5.0 Pre-Application Engagement

5.1 Pre-Application Meetings

Proposed Development at Pre-App 01

Pre-App 02 Proposed sketch section.

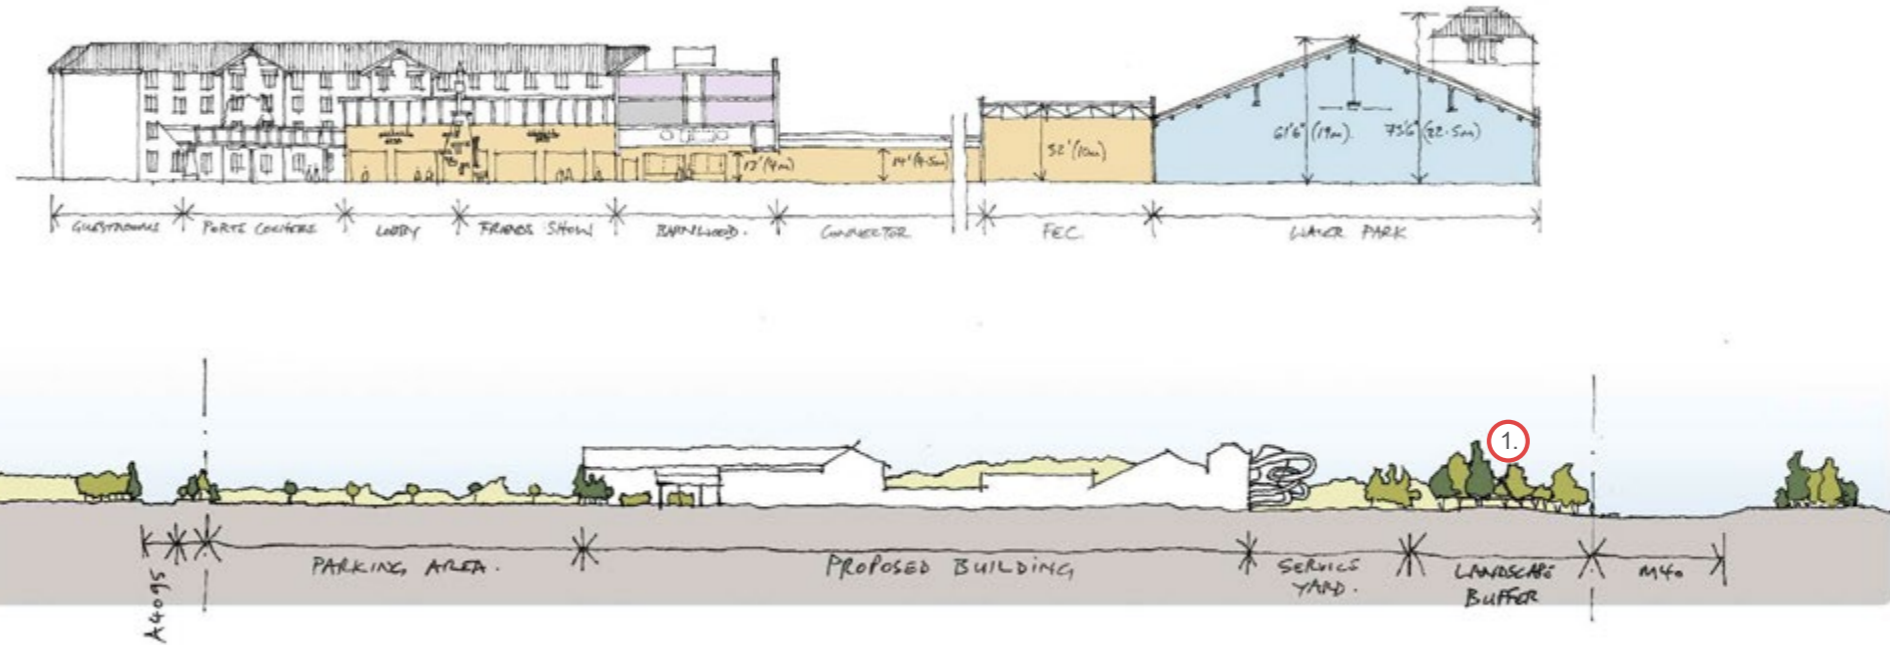
1. Retention of as many trees as possible is advised. Proposed building to move further from M40 to allow greater landscape buffer.
 2. U-shaped design and single ridge roof / gutter line to be broken down. Mass to be broken down and details like façade treatment and window location to be explored.

3. The Proposed Development must deliver a sense of England and Oxfordshire through the façade architecture.
 4. Landscape buffer for road from the A4095. Break up large mass of car park in different zones, using existing landscape where possible.

- Green roofs to be considered for the Family Entertainment Centre (FEC) to enhance the views from the hotel rooms overlooking the top of the FEC.
 - Scale and massing of proposed building to be reduced as much as possible.

- Prepare existing and proposed drawn sections across the 10th fairway buffer to show changes created by landscaping. Management and maintenance report recommended.

1. Building is repositioned further away from the M40.
2. The guestroom massing is changed from straight residential wings to a stepped plan form.
3. Façade studies propose a palette of locally used materials to clad the elevations of the building such as banding of stone and sage green timber board cladding.
4. Car park layout is redesigned to include additional landscape features and to zone parking areas surrounded by pockets of landscape / trees.

Proposed Repositioning of the Building.

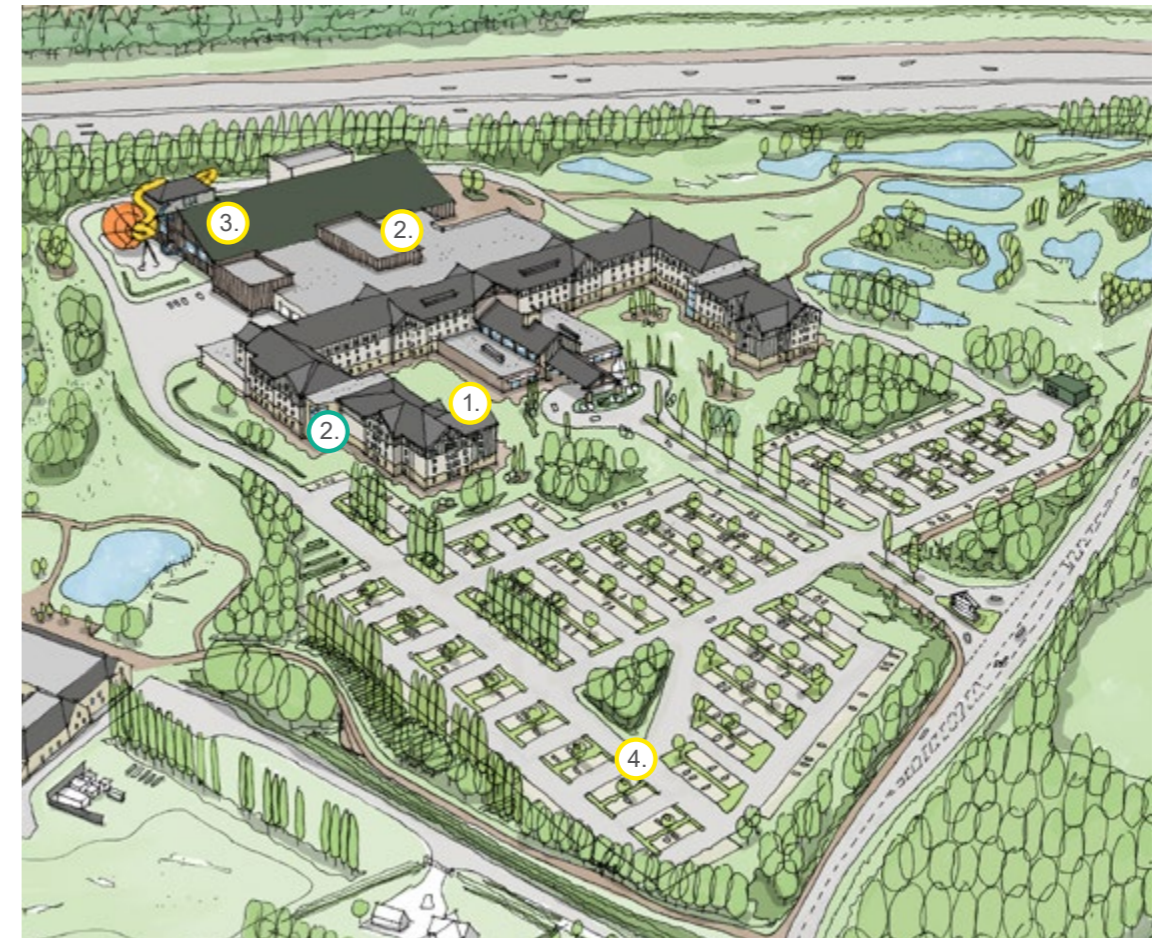
1. Consider if the guestroom wings can be reduced in height.
2. Visibility of the FEC to be reduced in views and elevation treatment to be considered.
3. Consider incorporating local distinctiveness to the Water Park building and respond to typologies of other large buildings set into the landscape.
4. The car park to have more of a soft landscaped emphasis.
 - Clarity sought on the extent of retained and proposed trees.
 - Confirm strategy for diversion of PROW.

1. Guestroom wings are partially reduced from four storeys to three storeys.
2. FEC has the same material as the hotel but different character. It is perceived as being set back from the taller Water Park and guestrooms. The FEC may incorporate a green roof to reduce visual impact.
3. The Water Park takes inspiration from rural barns and farm buildings, using green coloured steel or timber panels.
4. Certain bulk of car parking space is broken up by trees and greenery.

Guestroom wings reduced in height.

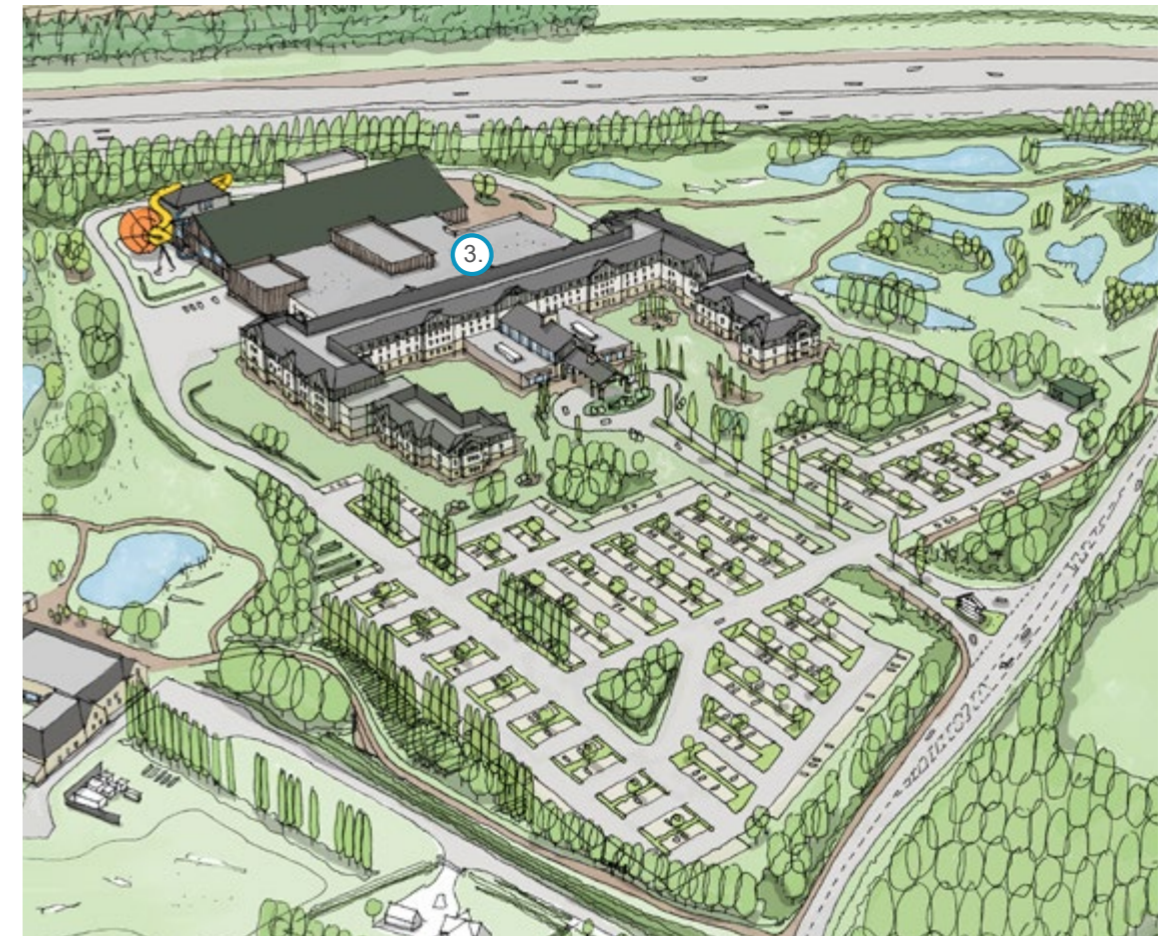
1. Simplify elevational design- address over-banding.
2. Review overly shallow pitches to roofscape design.
3. Break down central guestroom spine through architectural elevational treatments.
4. Research local "Bicester Area" precedents for façades of the proposed building.
5. Architecture needs to be of high quality where visible from the A4095.
6. Consider varying window positions for the proposed building.
 - Consider roof appearance of the FEC.
 - Consider visibility of the building from the entrance along the A4095.

1. In the guestroom elevations, materials delineate through vertical bays rather than previous horizontal banding.
2. In the guestroom wings, steeper roof pitches are given to bays and features. Roof proportions remain well-maintained against façade.

3. Bulk of guestrooms are visually broken down through the allocation of vertical bays, the hierarchy of materials and the varied roofscape.
4. Local Bicester elevation studies were conducted with findings incorporated into the design.

Guestroom wing clad in timber and lower in level.

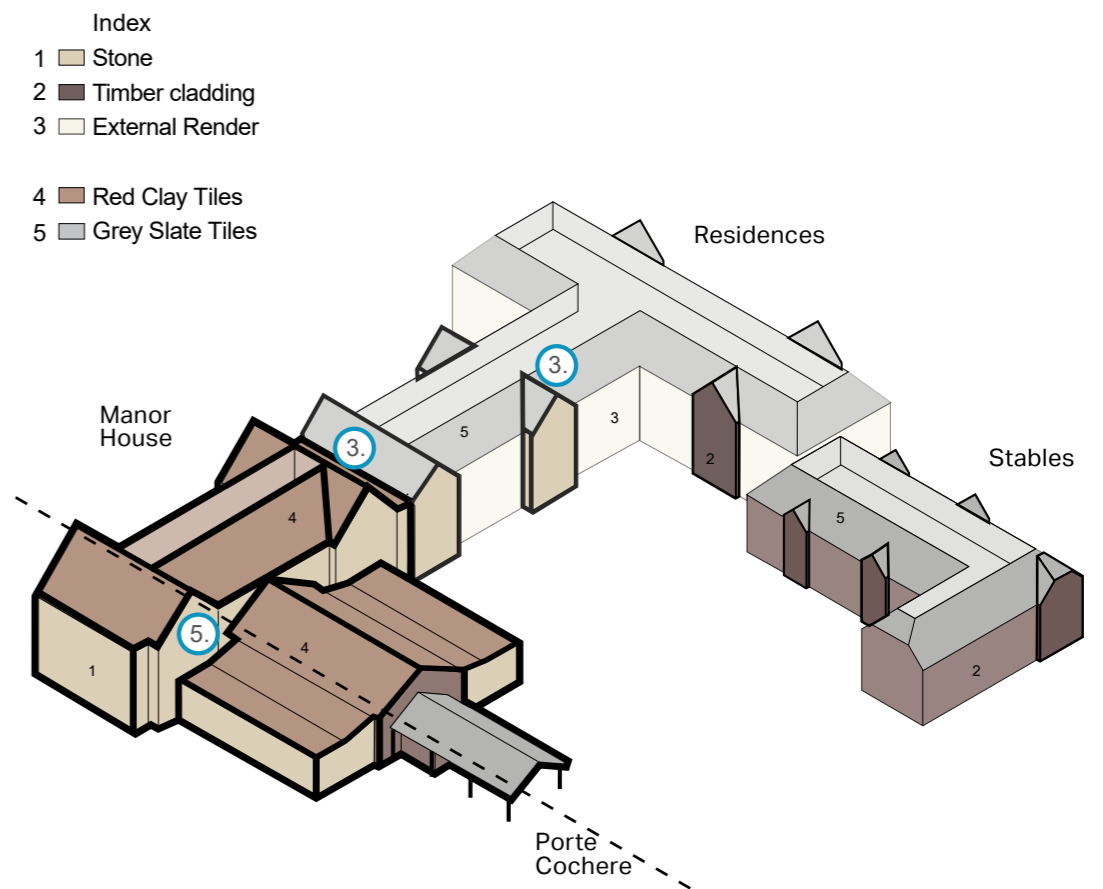
Feedback from Pre-App 05

1. Elevational design and over-banding have been simplified.
2. Pitches to roofscape design have been updated to reflect the local character of Chesterton and Bicester.
3. Hierarchy of the massing, materiality and façade treatment has helped with the break down of the central guestroom spine.
4. Façade study based on research of the local "Bicester Area" precedents has influenced the elevational design.

Detailed Elevation Studies.

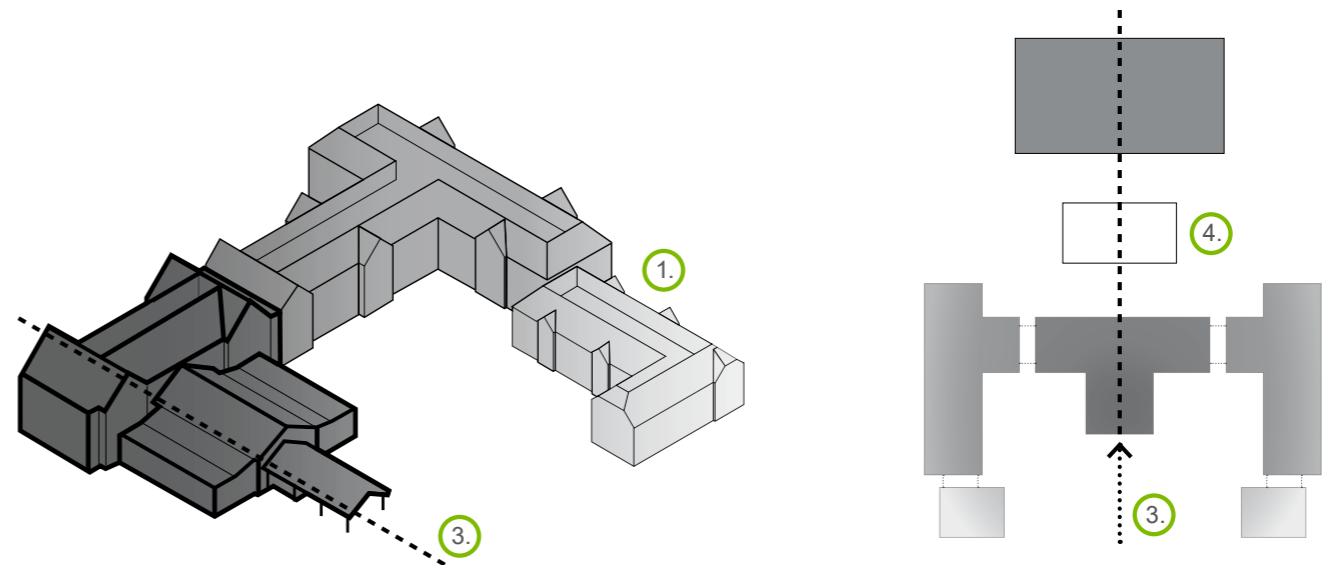
1. Appropriateness of the materiality of the 3 storey guestroom elements to be investigated.
2. Consider the positions of windows in the guestroom wings from their rhythmic setting out.
3. Overall symmetry of the proposed building could be softened.
4. Consider further visibility of the Proposed Development.

1. 3-storey elements are clad in timber to reflect the concept of the hierarchy in the material construction of the guestrooms. The central approach to the 'manor house' front is most visually prominent (stone), reducing in prominence as they branch out in the guestroom wings (render and then timber).

2. Positions of windows were repositioned and made less regular on the hotel's main elevations, grouping the windows together to break up the rhythm of the façade.

3. The architectural brief is to create a bespoke model for the Great Wolf Lodge inspired by local context and the British manor house, which calls for an overall symmetry in the plan form. Symmetry of the proposed building is softened with the repositioning of the windows (see point 2).

4. The architectural approach is not to disguise the building but to create a unique and bespoke architecture appropriate to the context. The overall mass of the Proposed Development is broken down into three smaller, separate components- the hotel, the Water Park and the lower lying FEC.
